ALERT SERVICE BULLETIN

REPLACEMENT OF ROTARY BUCKLE

SERVICE BULLETIN NUMBER
1150004-25-A01
ISSUE 7

ISSUED BY:
AMSAFE INC.
1043 N. 47th AVENUE
PHOENIX, AZ USA 85043
TEL: (602) 850 2850 FAX: (602) 850 2812

Figure 2: Inspect the Cover for Looseness

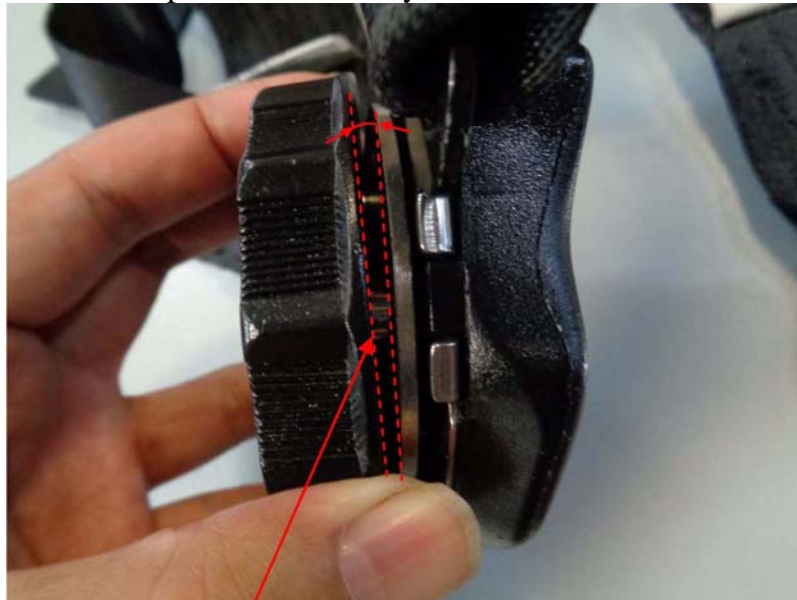
indicated in paragraph 1.A., (see Paragraph 2.A. for information on identifying the build date) then no further action is necessary. If the buckle build date is within the date range of this service bulletin, or if the build date is illegible or missing, check the buckle cover (front face that rotates to release the buckle). Viewing the buckle from the side, grasp the cover with one hand and attempt to rock the cover back and forth relative to the parallel plane of the buckle base (See Figure 2). If the cover is able to rock, so that there is a changing gap width between the buckle cover and buckle base, then the buckle must be replaced immediately.

If the above condition does not exist, the restraint can be returned to service, the buckle to be replaced within 180 days of the inspection, during a suitable maintenance interval, per §2 (Accomplishment Instruction). Buckles replaced under this service bulletin, whether due to manufacturing date within the build dates indicated or an illegible manufacturing date on the label shall be free of charge.
